**From:** [Hogan, Matt](#)  
**To:** [Gilles, Benjamin M](#); [Fox, Trevor T](#)  
**Cc:** [Armitage, Stacy A](#)  
**Subject:** FW: [EXTERNAL] Re: Fence Drawing  
**Date:** Friday, December 9, 2022 5:18:42 AM  
**Attachments:** [Wildlife Crossing Suggestions for Grizzly Ridge Bison Fence.pdf](#)  
[ATT00001.htm](#)

## Wildlife Crossing Suggestions for Grizzly Ridge Bison Fence

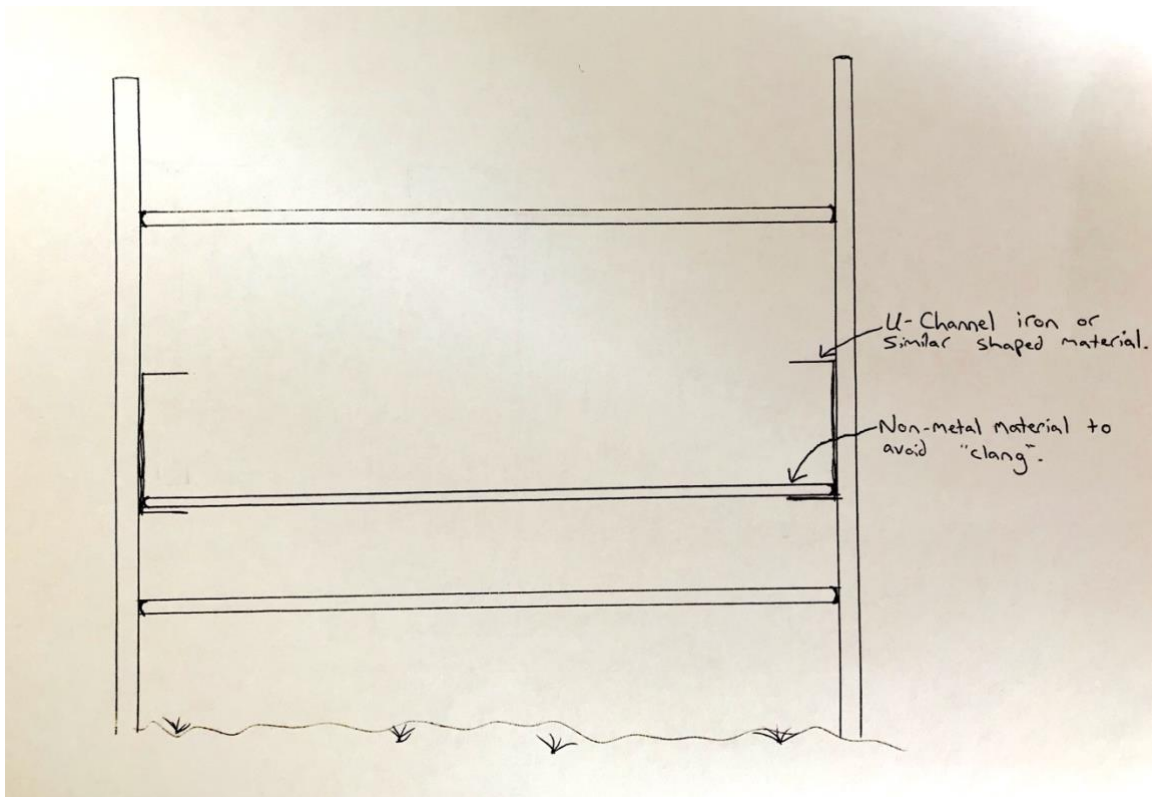
The current perimeter fences are 5- to 7-foot field fence supported by metal posts. Given this fence design, the most efficient crossing design would be to use 2 or 3 metal pipes as rails, welded or otherwise fastened securely to the metal posts (see photo).

- 1) Place bottom rail at least 18" above ground level to allow wildlife to pass under (especially young ungulates and mule deer).
- 2) Normally, the recommended top rail height for deer and elk is 40" to 42", with middle rail at 30" to allow 12" between middle and top to prevent leg entanglements. However, this top height may not be suitable in all locations for bison fence.
- 3) If a higher top rail is necessary for bison, I suggest spacing rails at 18" bottom, 36" middle, and 48" to 54" top. This allows an 18" gap between the bottom and middle rail for animals to crawl through, and 12" to 18" between middle and top rail.
- 4) *I especially recommend at least 18" between the bottom and middle rail for moose calf crossing.*

In addition, Andrew Pettibone (USFWS, Choteau, MT, [Andrew\\_pettibone@fws.gov](mailto:Andrew_pettibone@fws.gov)), who was part of the tour, suggested a trial for a moose calf crossing with a moveable middle rail that will float as an animal pushes between the bottom and middle rail. This could be easier for moose calves to negotiate – see illustration.

The floating rail should be of durable non-metal material to avoid clanging. It should be held in place by U-channel or similar box shape to allow the rail to slide up and down but prevent it from popping out.
